# Environmental Minor Project Refinement Form

Project Name: West of Devers Upgrade Project Request Prepared By: Sylvia Granados

Date Approval Required: 10/9/2018 Variance Request No.: 21

FIGURE 1  
Page 1 of 6

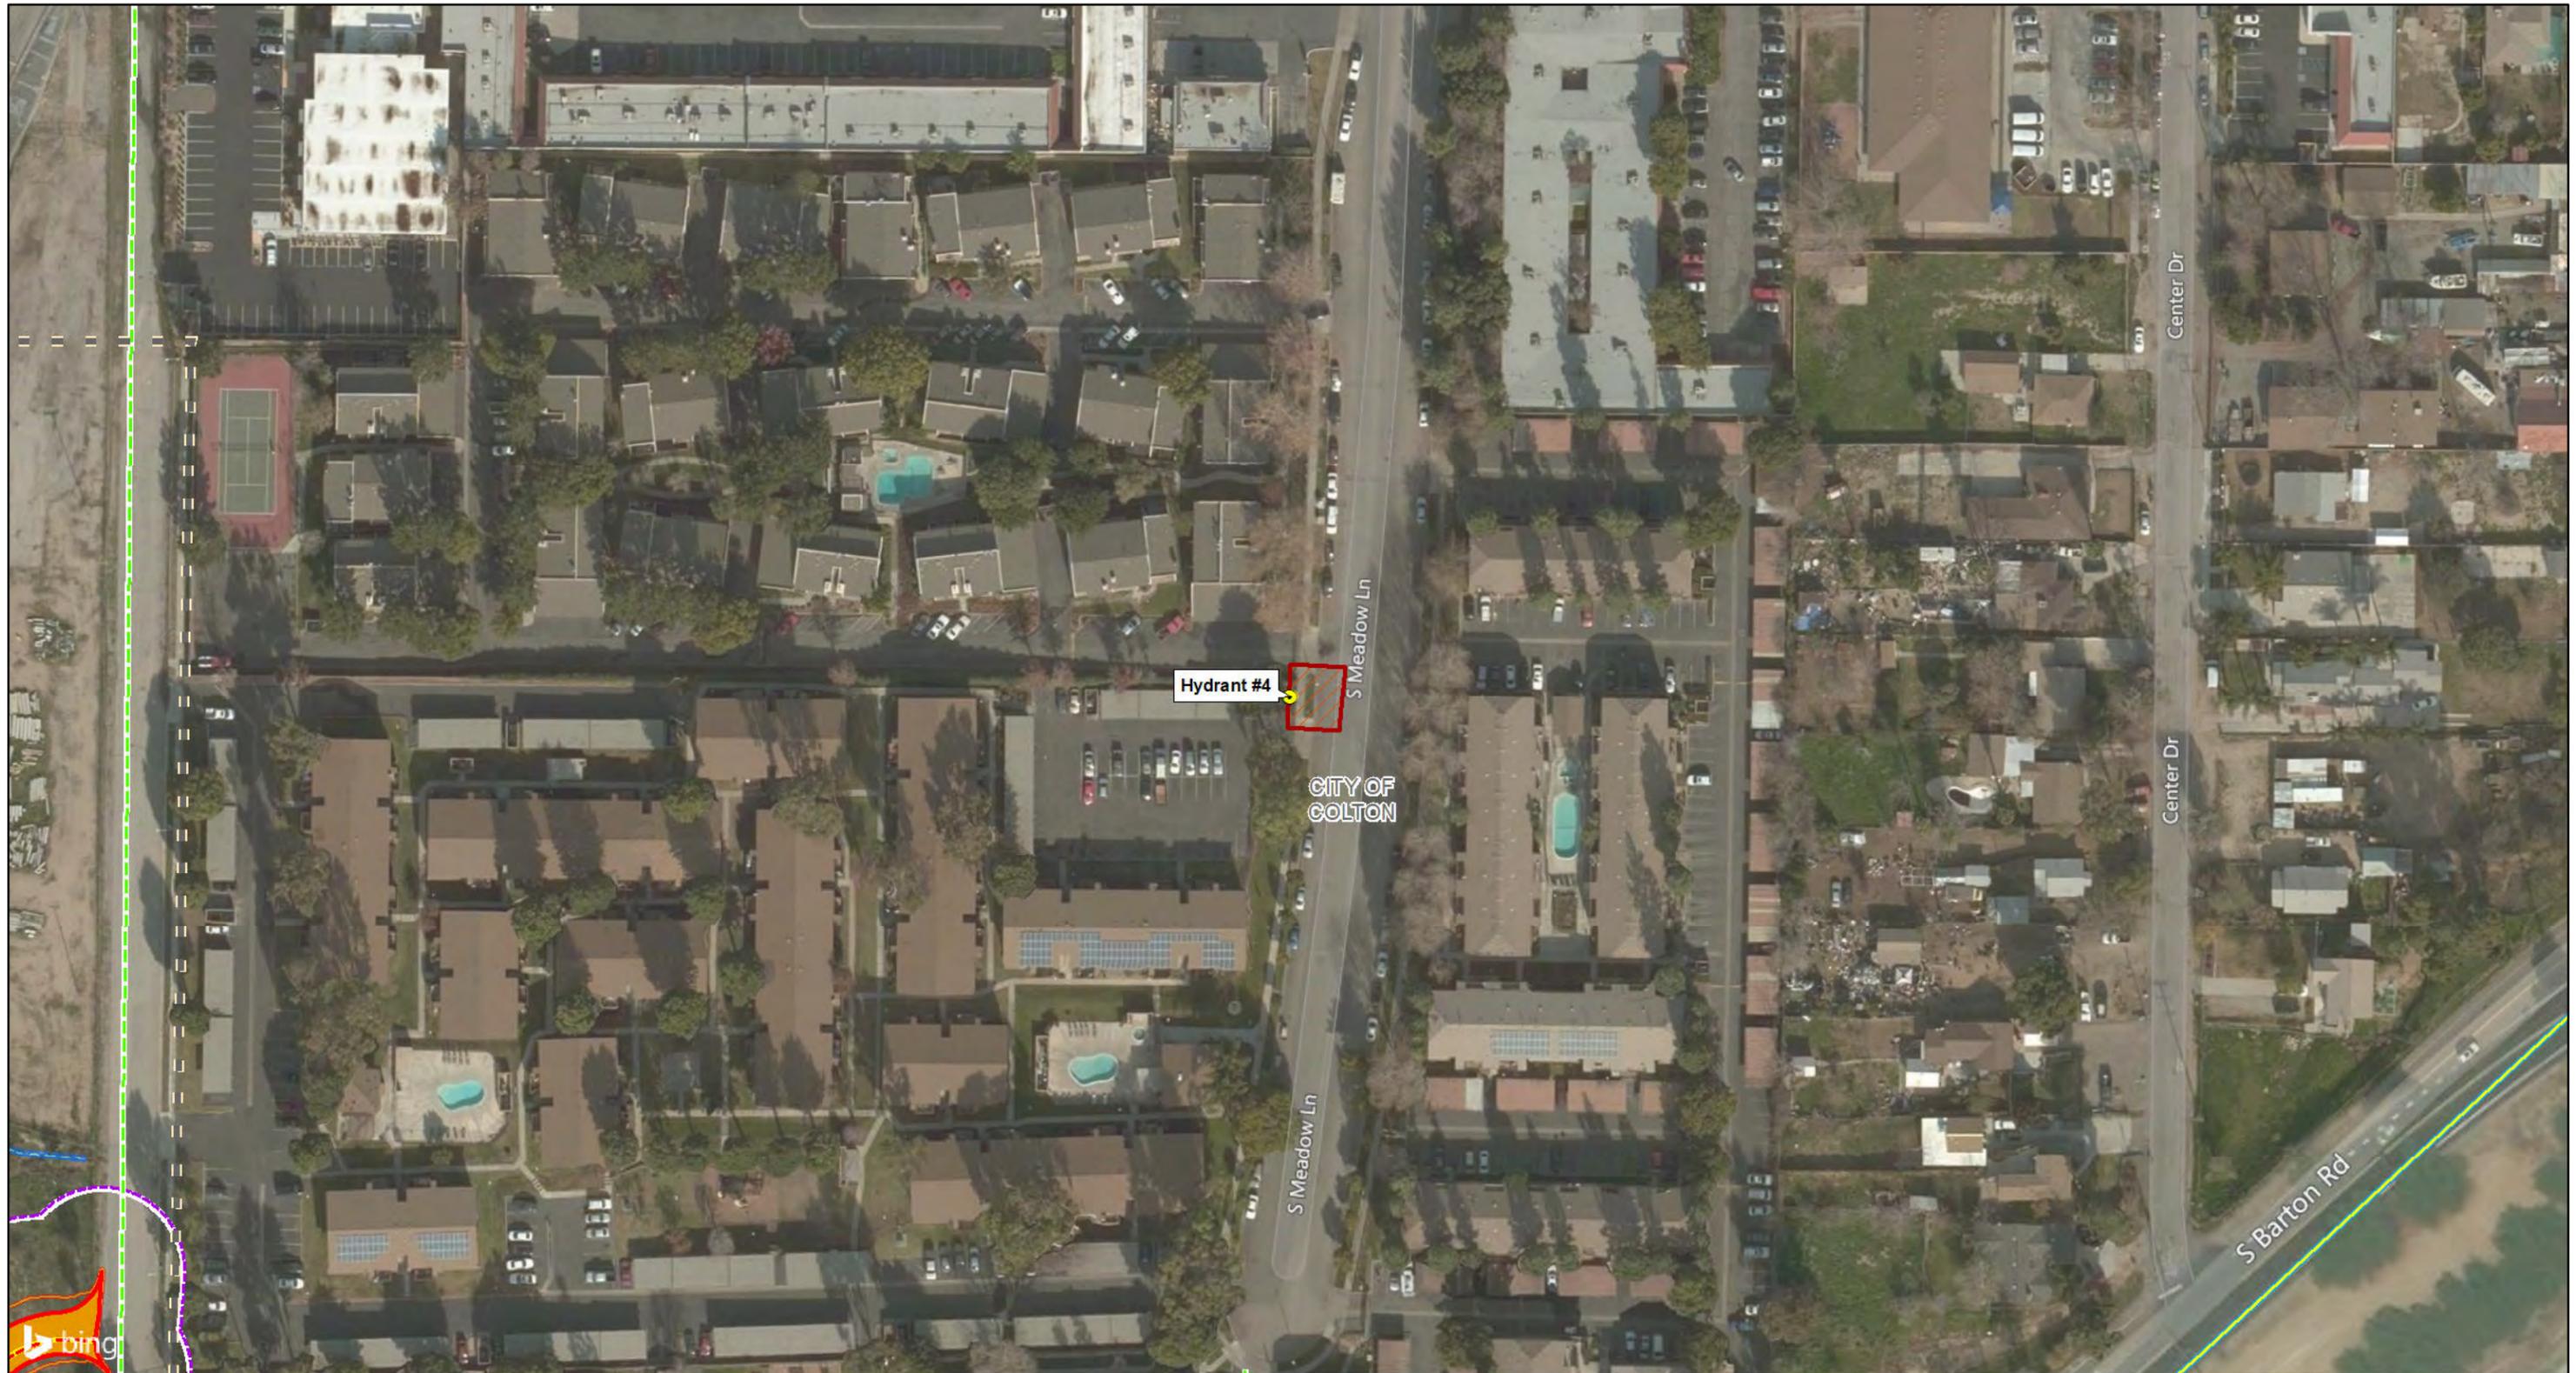
**Hydrant #1** – Potable hydrant supplied by Beaumont-Cherry Valley Water District, located on the west side of Desert Lawn Drive, south of Oak Valley Parkway (33°56'36.25"N, 117°0'12.06"W) in the city of Beaumont, shown on Figure 1, page 1.

FIGURE 1  
Page 2 of 6

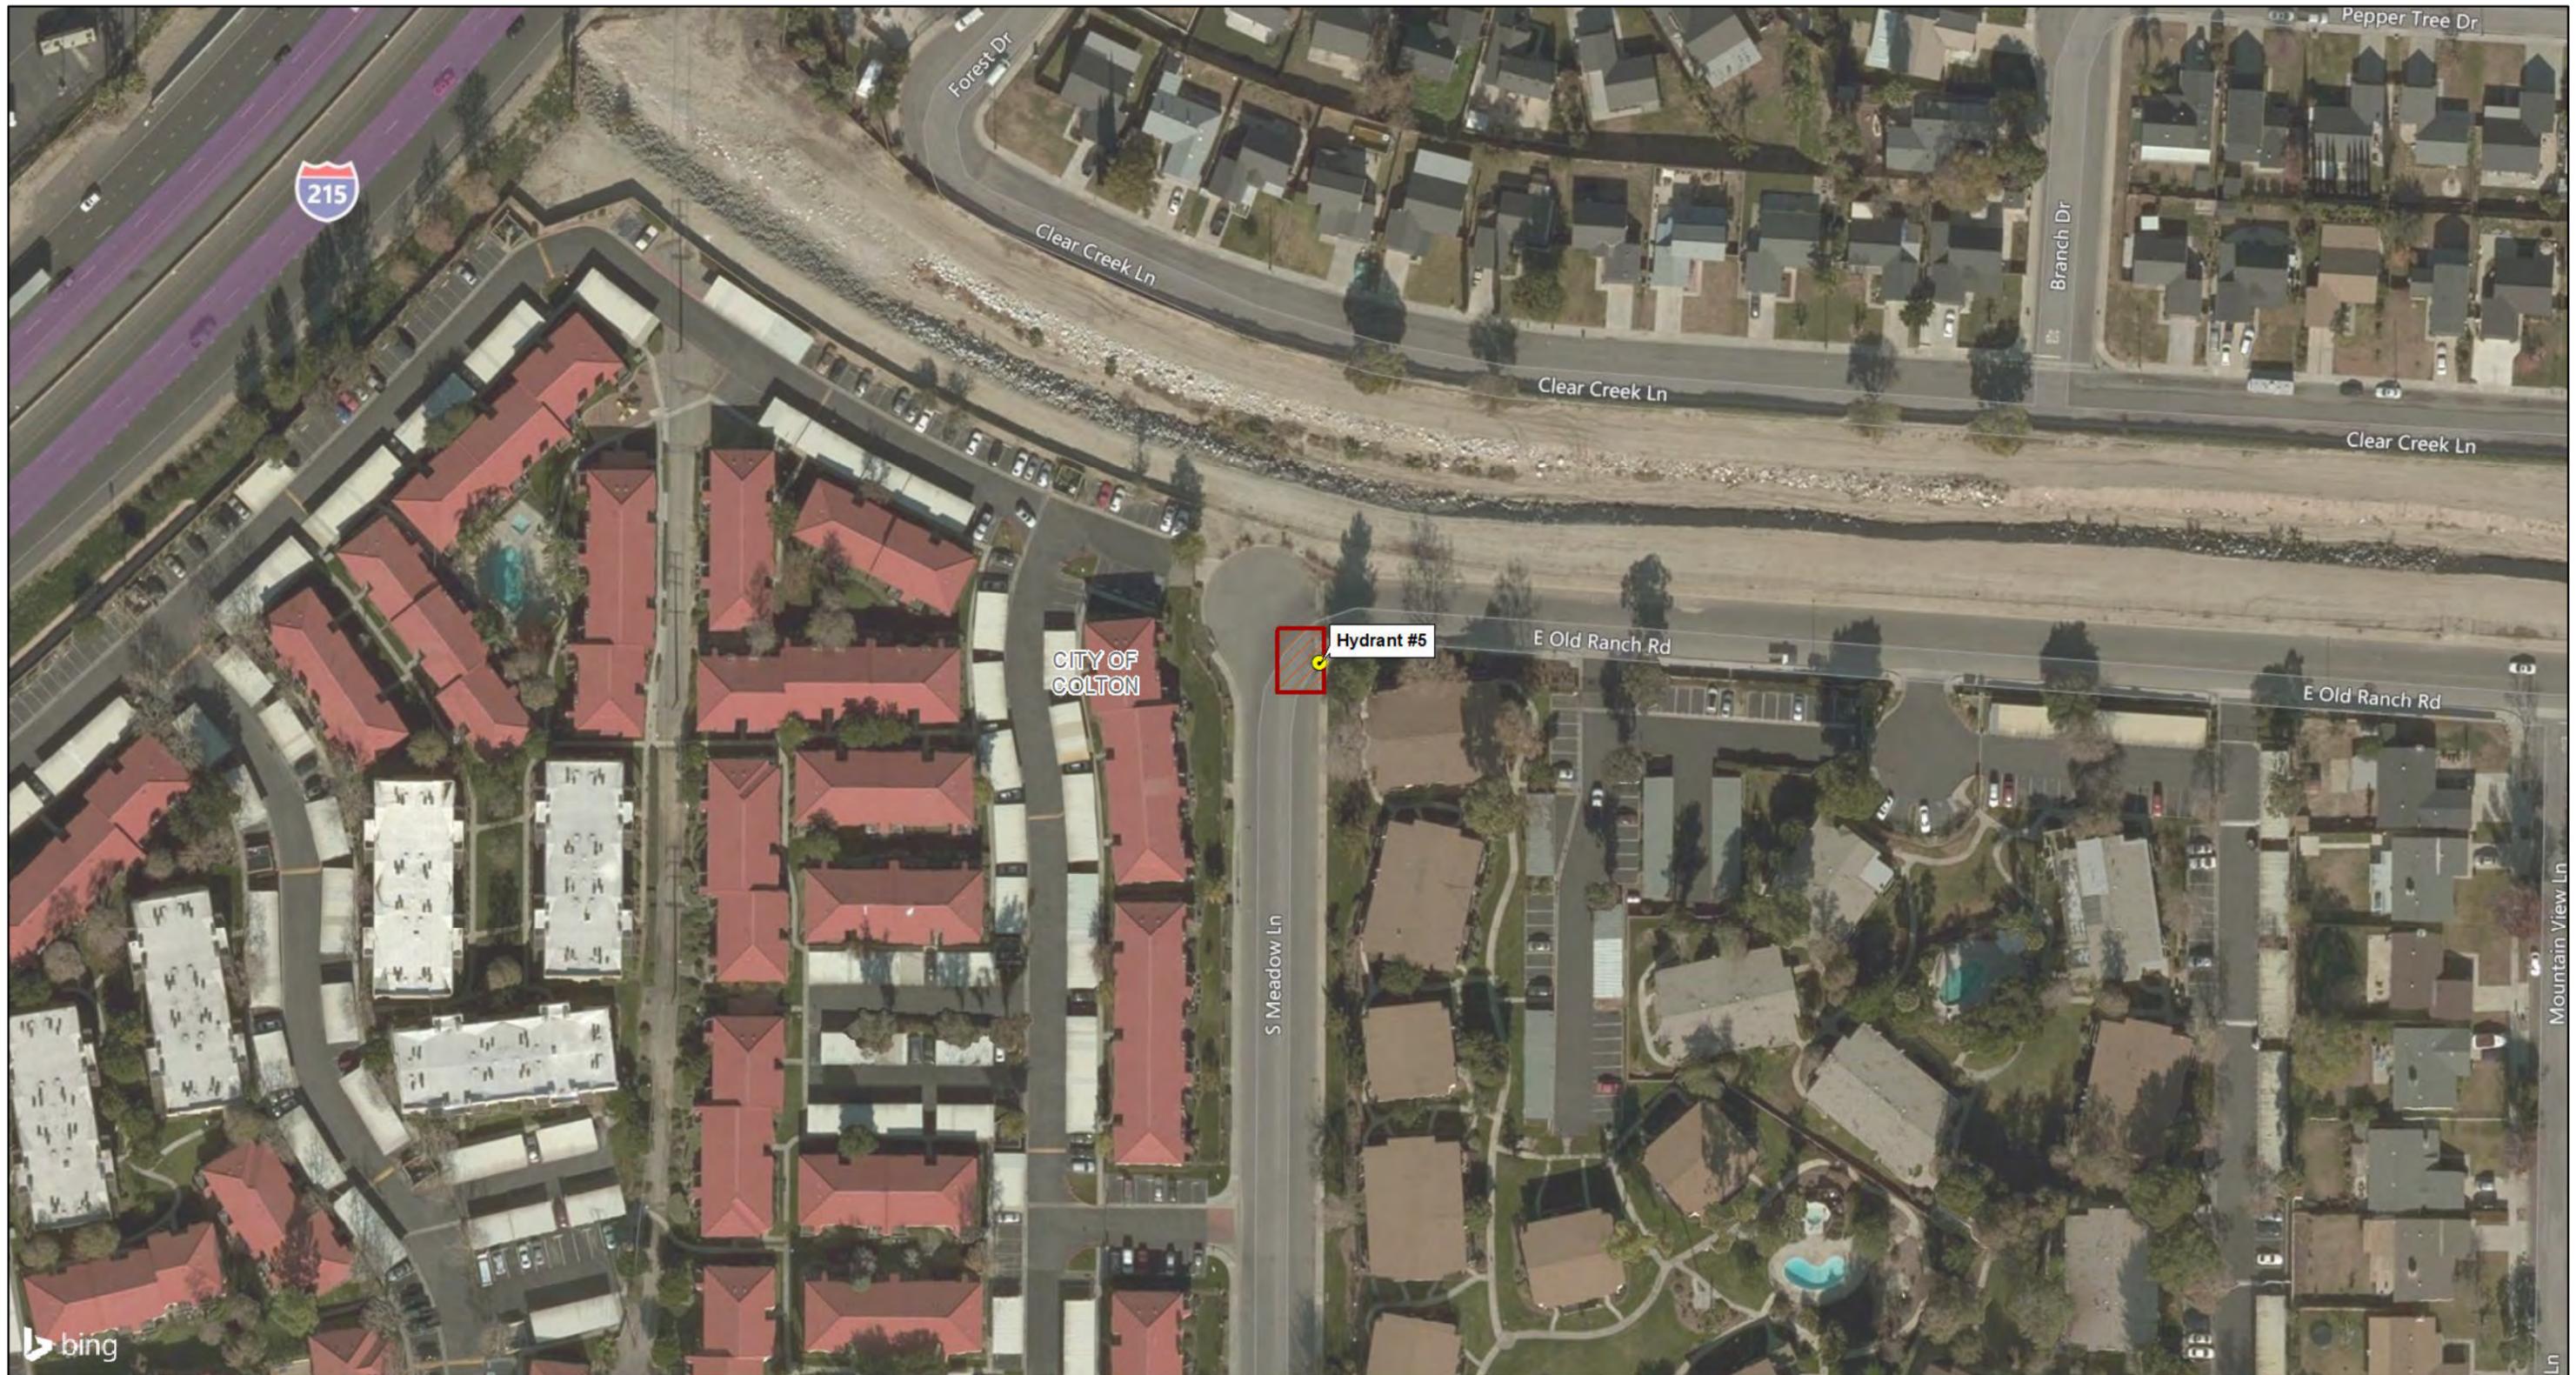
**Hydrant #2** – Potable hydrant supplied by the city of Redlands, located on the south side of Creekside Drive, east of Alessandro Road (34°0'50.58"N, 117°10'39.14"W) in the City of Redlands, shown on Figure 1, page 2.

**Hydrant #3** – Potable hydrant supplied by the city of Redlands, located on the south side of Creekside Drive, east of Hydrant #2 (34°0'47.66"N, 117°10'33.53"W) in the City of Redlands, shown on Figure 1, page 2.

FIGURE 1  
Page 3 of 6

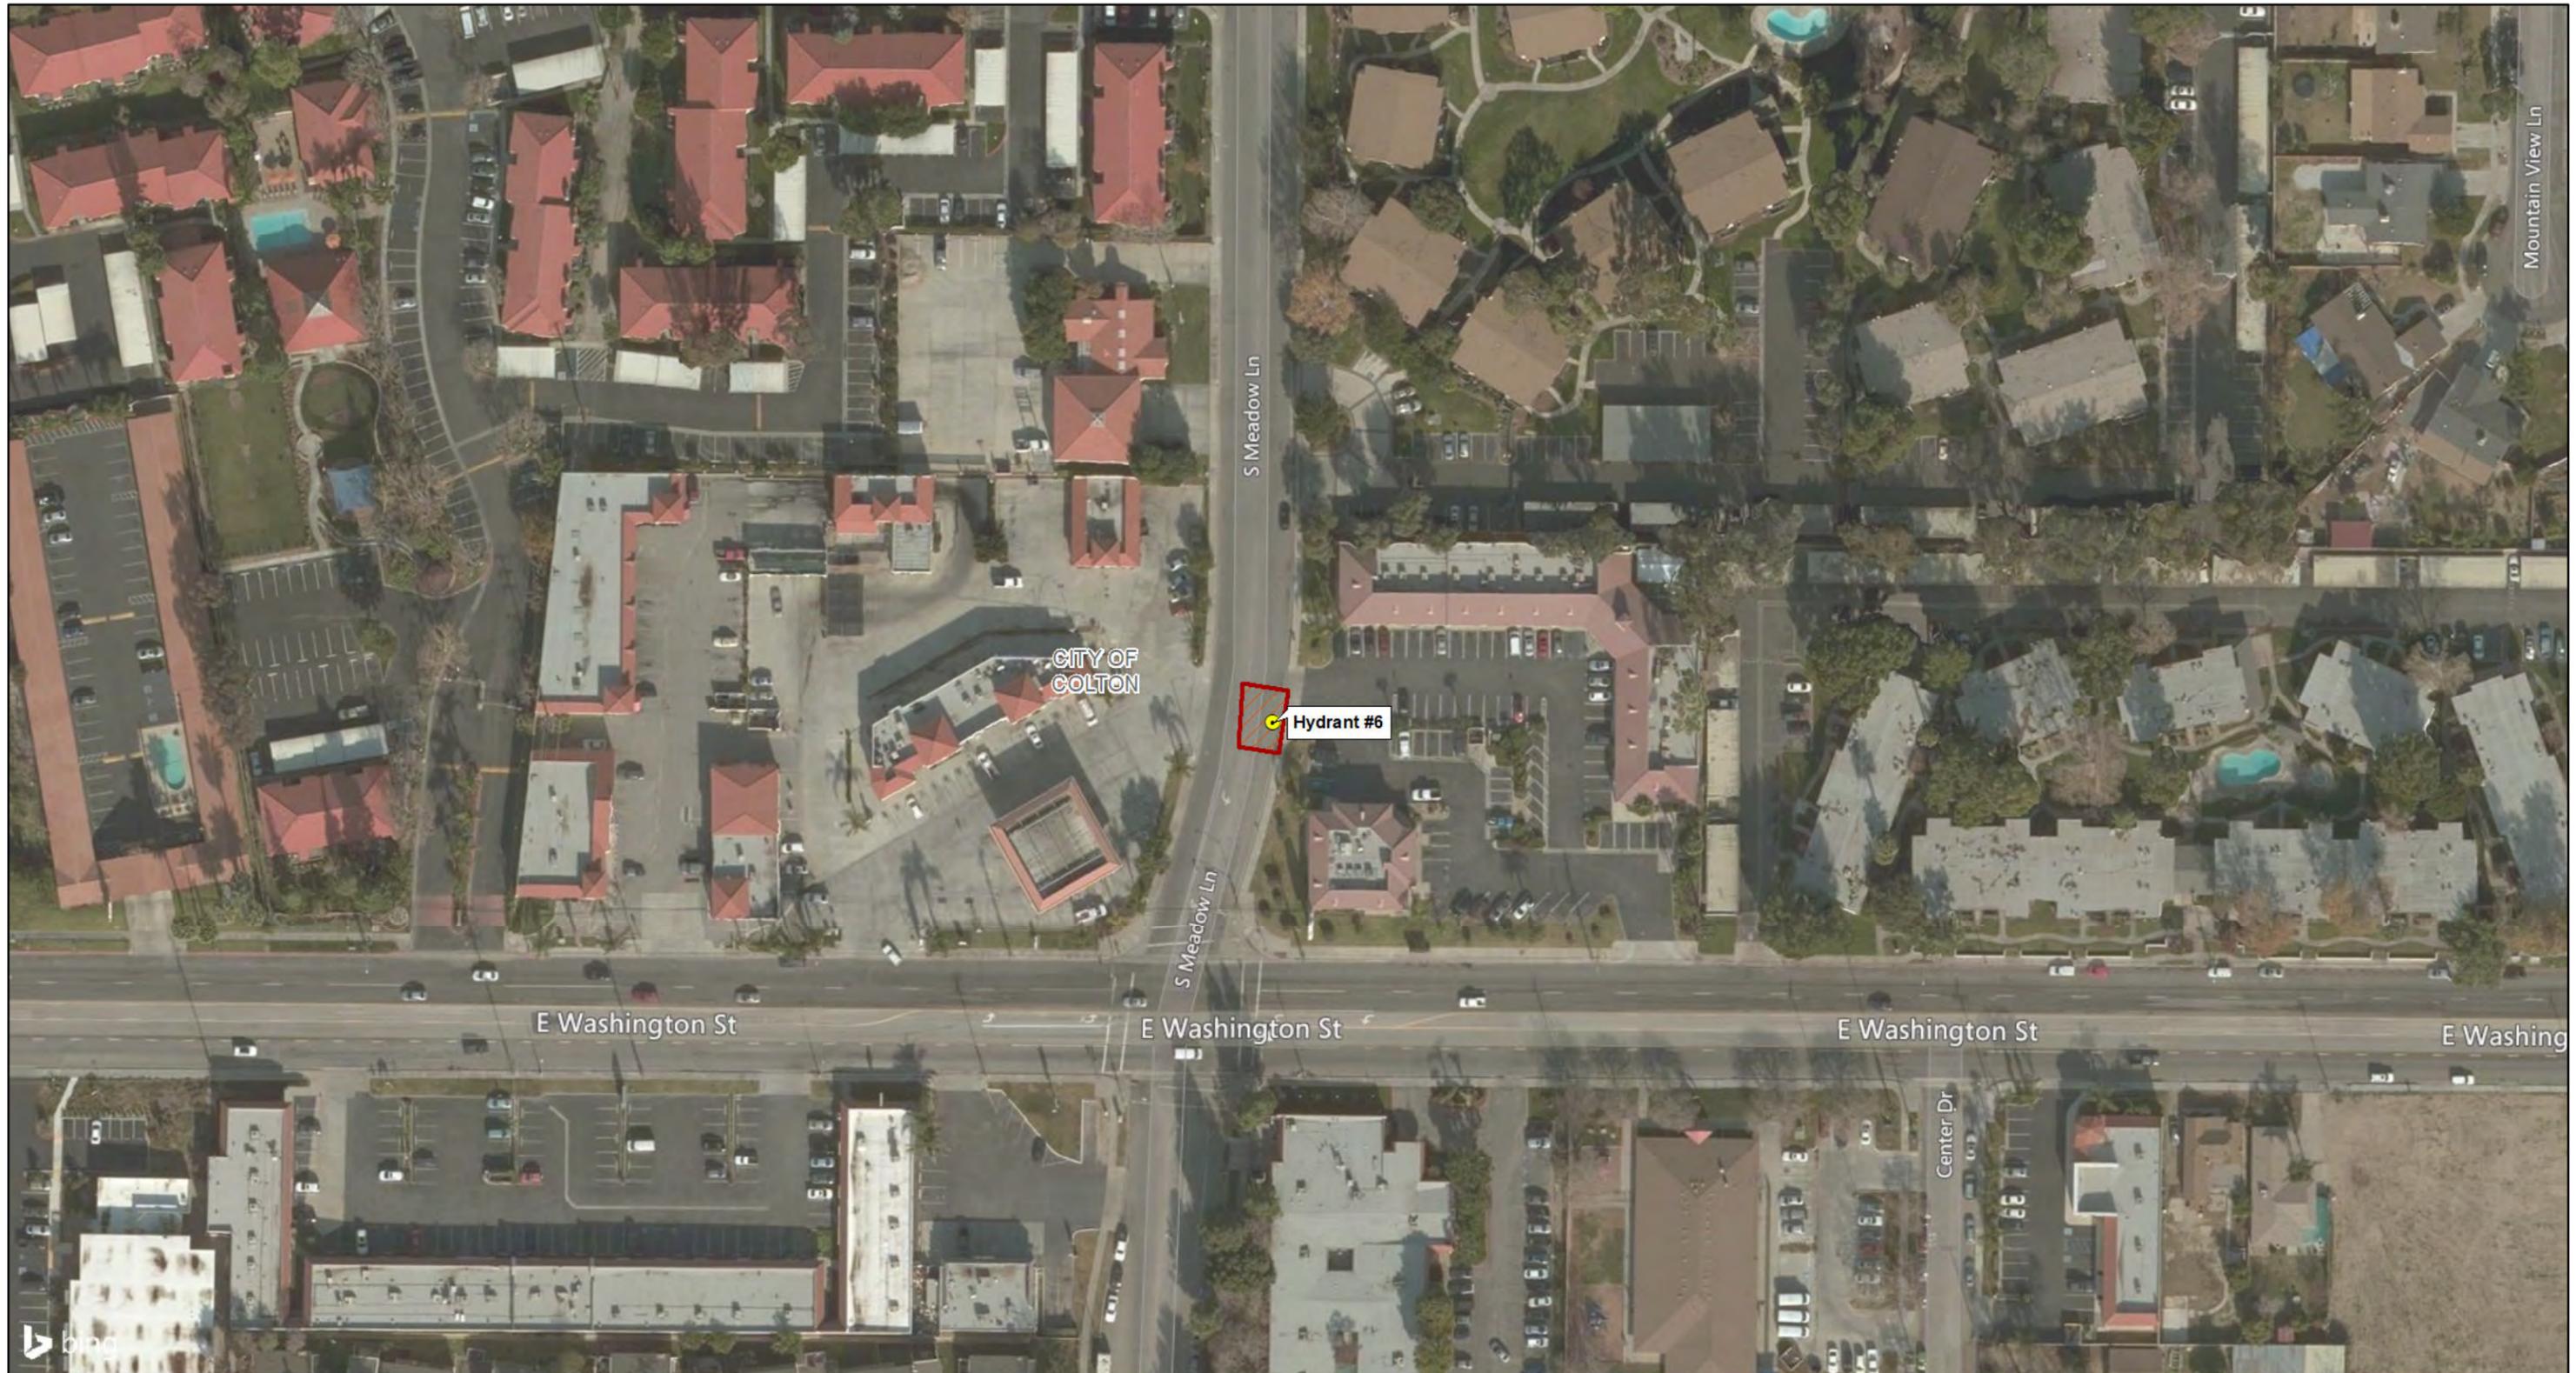
**Hydrant #4** – Potable hydrant supplied by the city of Colton, located near 1311 South Meadow Lane (34°2'49.01"N, 117°17'58.73"W) in the City of Colton, as shown on Figure 1, page 3.
